Design/Constructability Staff Review Team

Oak View Group:

KEY ARENA RENOVATION

FIGURE 7
TRUCK TURNING
DIAGRAM

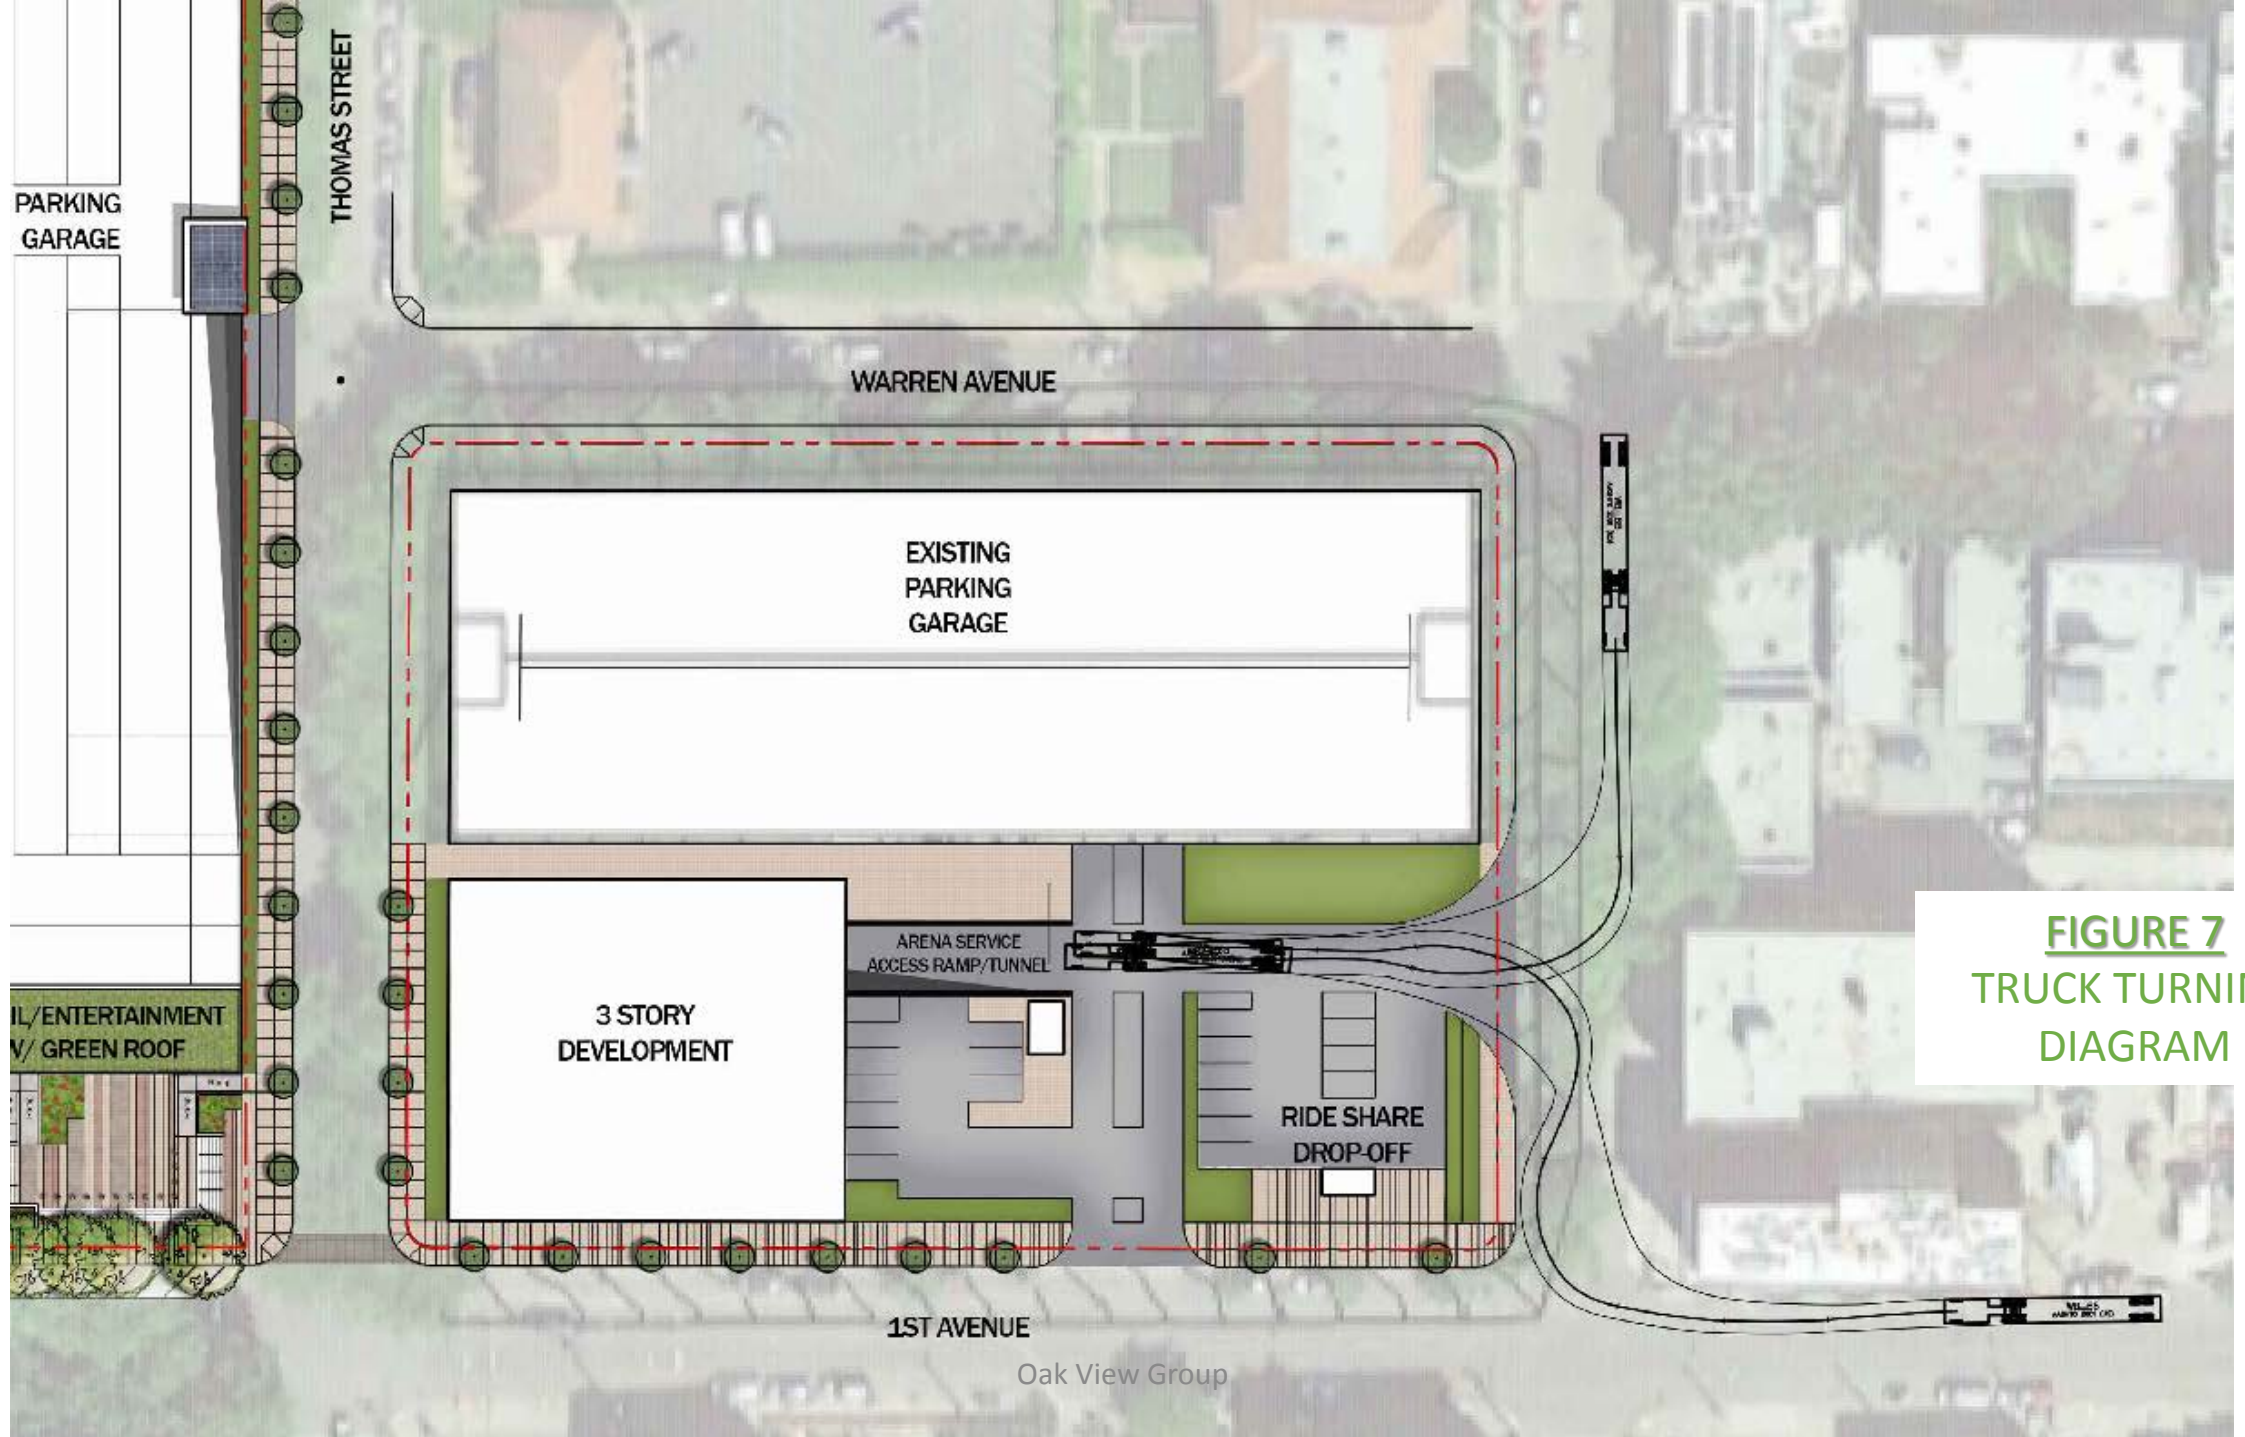
During building operation, there may be concerns about truck loading at John and 1st Ave N. (Figure 7). We suggest they investigate the Barclays Center’s solution of using truck elevators and turn-tables before finalizing this design element.
